Proposed Plan to Amend the 2006/2011 Record of Decision Butte Priority Soils Operable Unit

#MTD980502777

April 2019

Figure 2
Locations of Surface Water Remedy Components
 Butte Priority Soils Operable Unit
 Silver Bow Creek /Butte Area Site

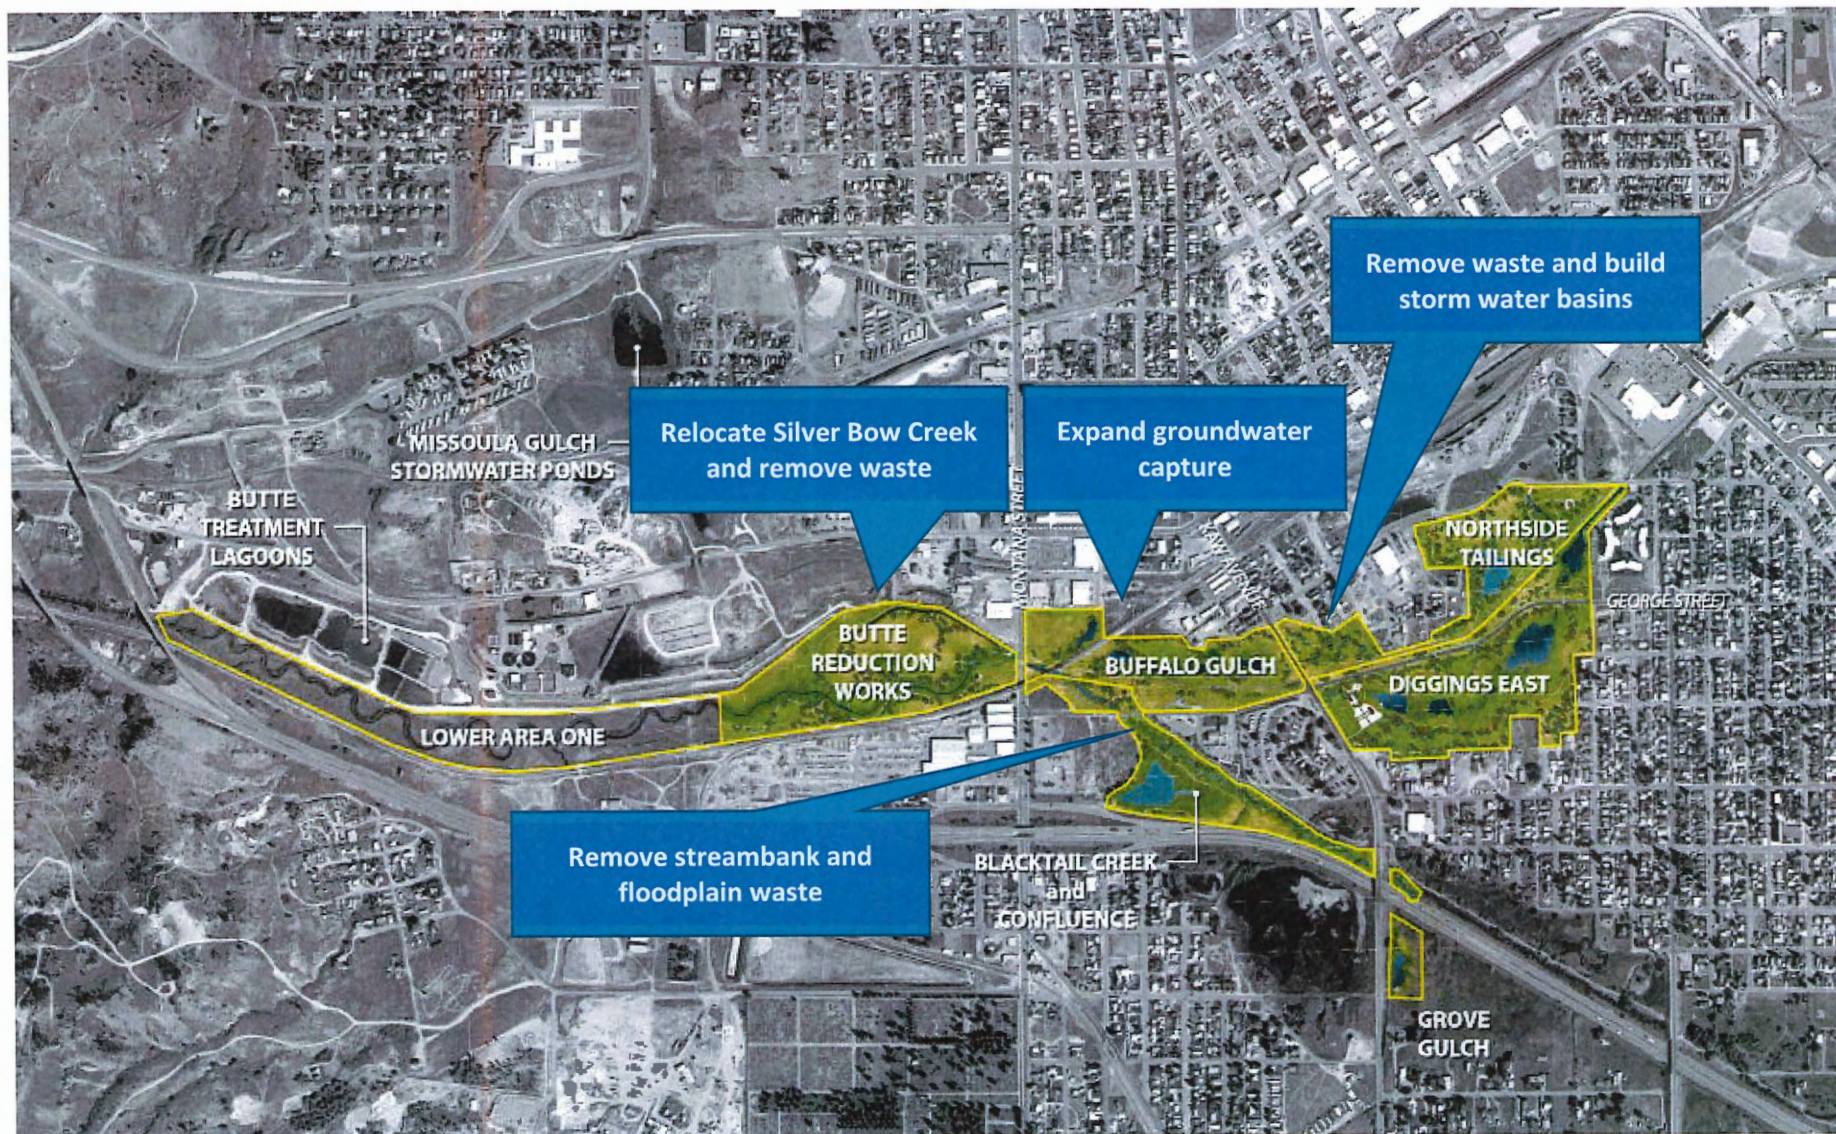
1. Significantly expand mine waste removal in upper Silver Bow Creek (associated with BMP implementation), the Blacktail Creek area, and portions of the Butte Reduction Works area. Reroute a portion of Silver Bow Creek around and away from the contaminant source at the Butte Reduction Works and Slag Canyon area and removing certain tailings and contaminated material in this area.
2. Add groundwater capture in areas west and south of the BPSOU Subdrain.
3. Specify large-scale BMPs for storm water control (locations and sizes of detention basins). These would be the final round of iterative BMPs called for in the 2006 ROD.

These elements are described in Table 2 and shown conceptually in Figure 2.

Existing ROD (2006/2011)		2019 Proposed Plan for ROD Amendment	
Component	Description of Component	Expansion	Description of Modified Remedy
Sediment and Waste Removal from Blacktail and Silver Bow Creek Channels	Excavate contaminated sediment, stream banks, and adjacent floodplain wastes from the reach of Blacktail Creek just above the confluence with upper Silver Bow Creek, through the slag canyon, and down to the reconstructed floodplain and stream channel in Lower Area One.	Expand waste removals in streams upstream and downstream of confluence. Move Silver Bow Creek out of Slag Canyon.	- Based on analysis of data collected during remediation and extensive public input, expand removals and require additional hydraulic control. Upstream direction. Add bank sediment and nearby floodplain waste removal along Blacktail Creek (George Street to Grove Gulch). Downstream direction. Remove tailings, slag, contaminated soils, and other waste from Butte Reduction Works (southern portion of the site) to allow Silver Bow Creek to be moved into the new corridor (Figure 2).

Figure 4
Revised RMAP Boundary
Residential Metals Abatement Program Expansion Area
 Butte Priority Soils Operable Unit
 Silver Bow Creek/Butte Area Site

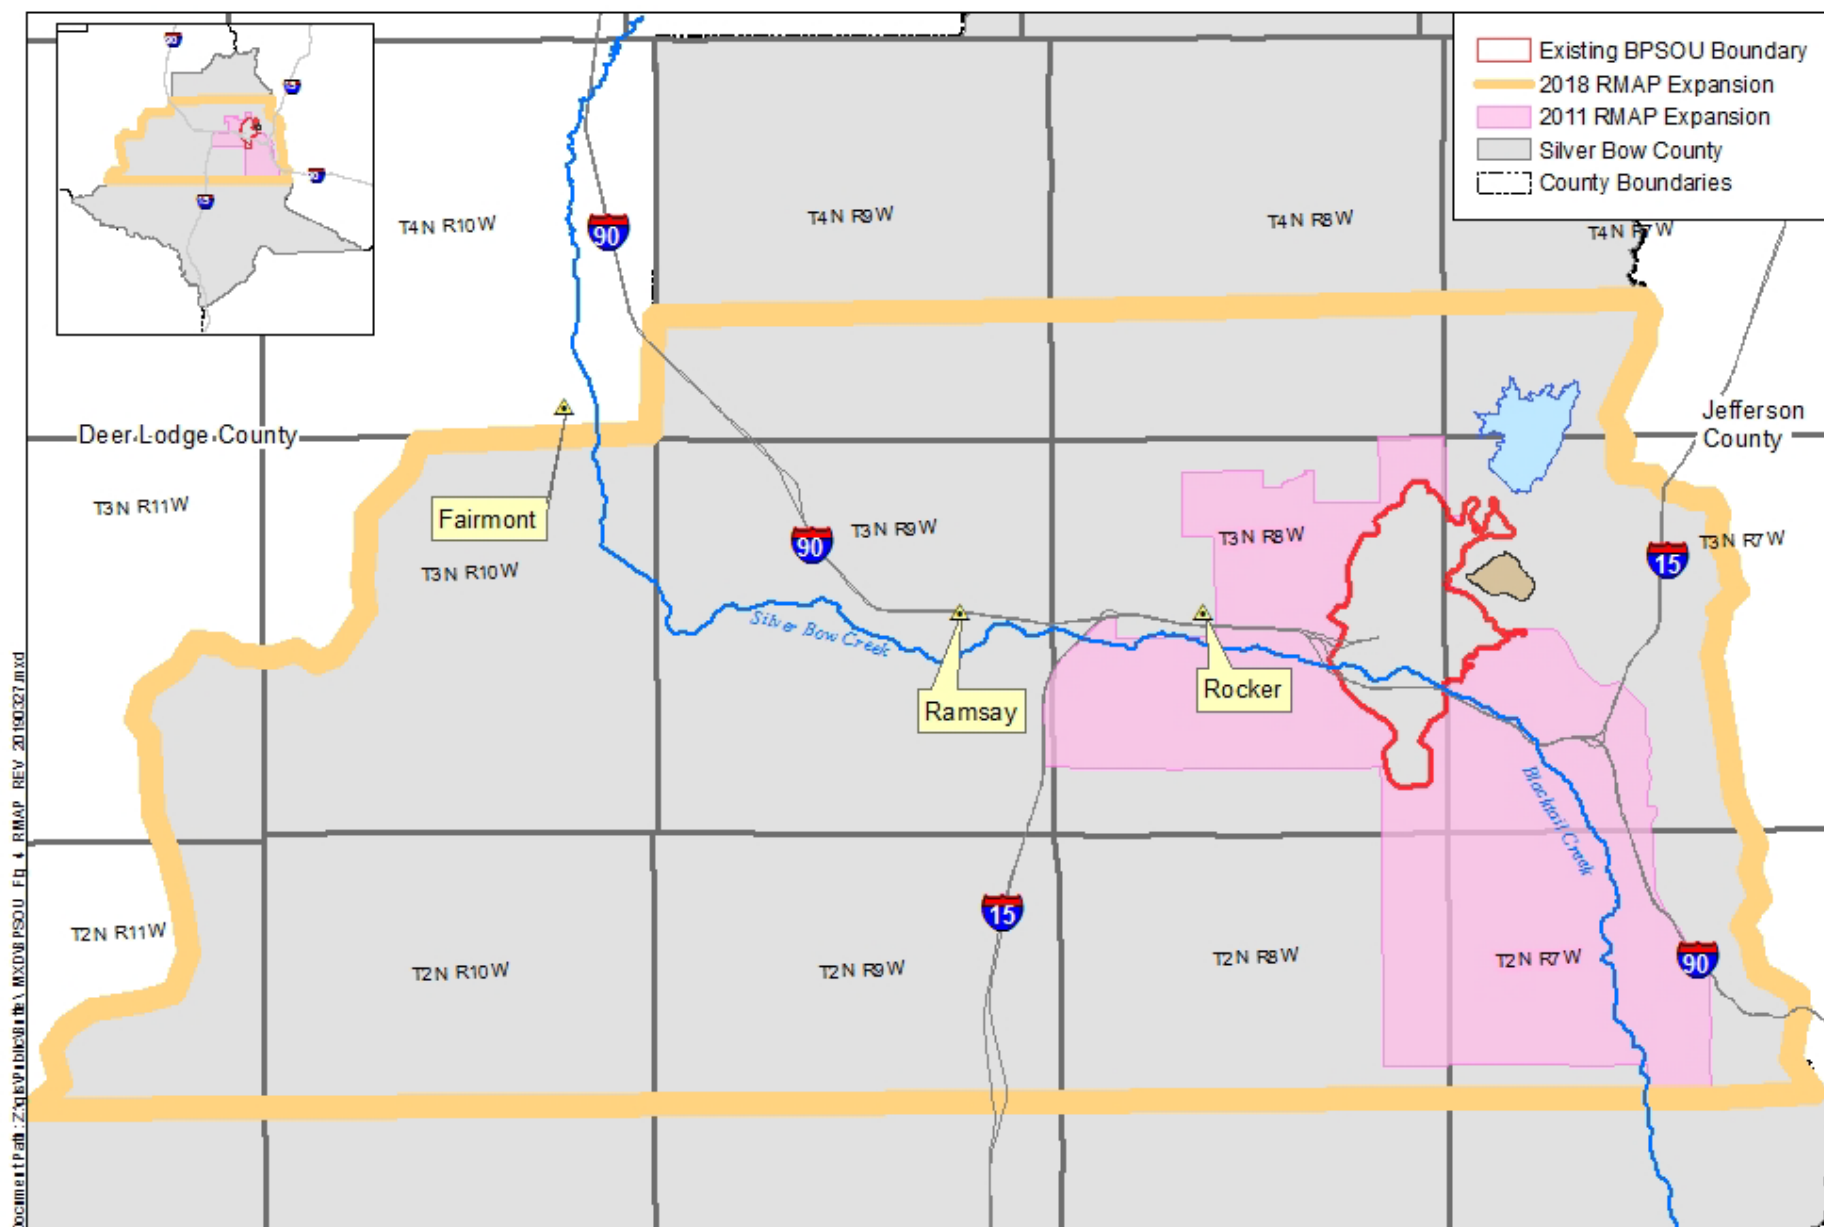
- 2. Change and expand the RMAP boundary.** The 2006 ROD allows for residential cleanup expansion, as needed. In 2011, the Residential Metals Abatement Program (RMAP) attic dust program was expanded to areas south and west of the BPSOU boundary, encompassing the southern urban area of Butte. This modification expands the RMAP boundary further to encompass rural residential development (outside the BPSOU) to the north, south, and west, including Rocker (Figure 4). Work in the expanded area will include all RMAP facets (soils, living area dust, lead-based paint, and attic dust) except for the property-by-property systematic sampling and assessment approach. Properties outside the BPSOU boundary but within the RMAP expansion area will be sampled by request only.

Figure 5
Proposed Surface Water Technical Impracticability Reach with Compliance Stations
 Butte Priority Soils Operable Unit
 Silver Bow Creek/Butte Area Site

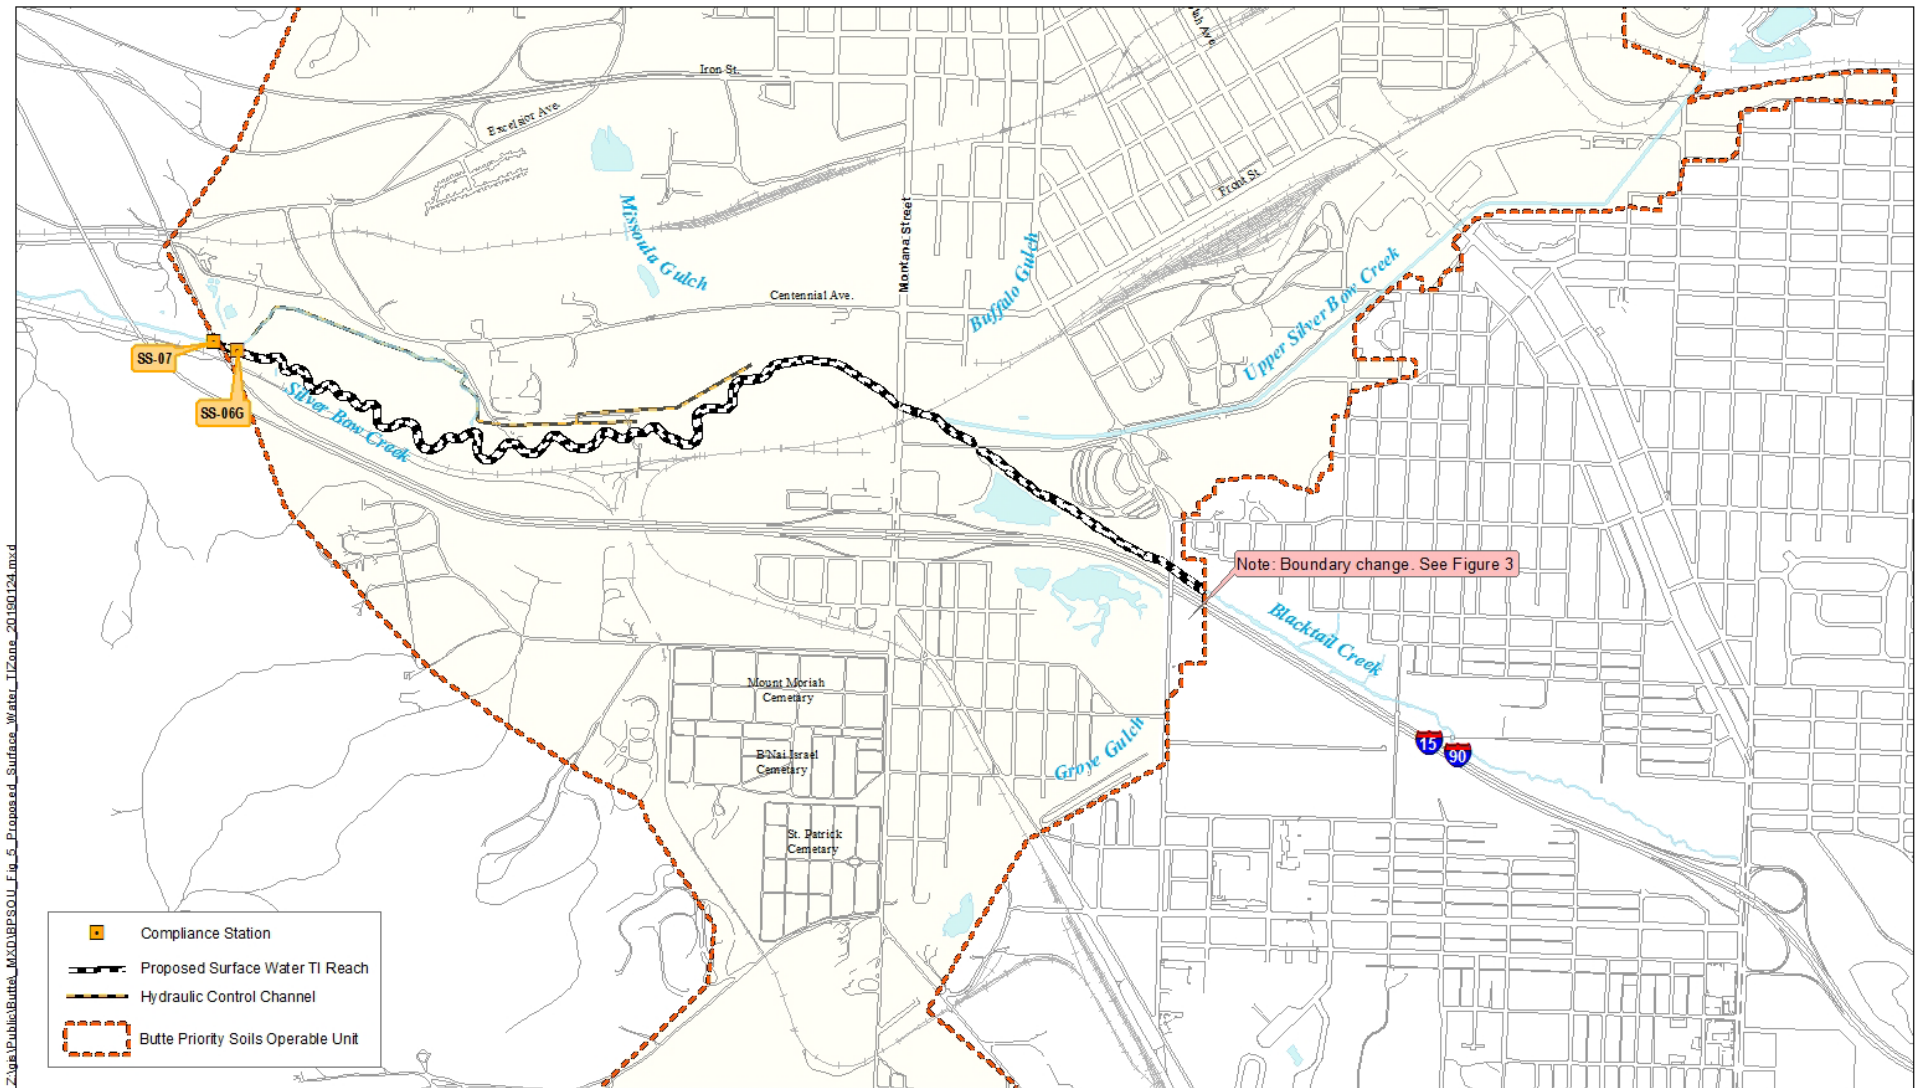
- 3. Revise points of compliance and determination of compliance.** The prescriptive surface water monitoring of the 2006/2011 ROD (Section 12.6.6.2) will be simplified to points of compliance at SS-06G and SS-07 (Figure 5). Other monitoring stations will remain in the network as needed, but

compliance will be determined at these two farthest downstream stations. Effluent from the Butte wastewater treatment plant enters between SS-06G and SS-07. The surface water sampling methodology will be modified to allow for additional compositing methods at the compliance sampling locations.
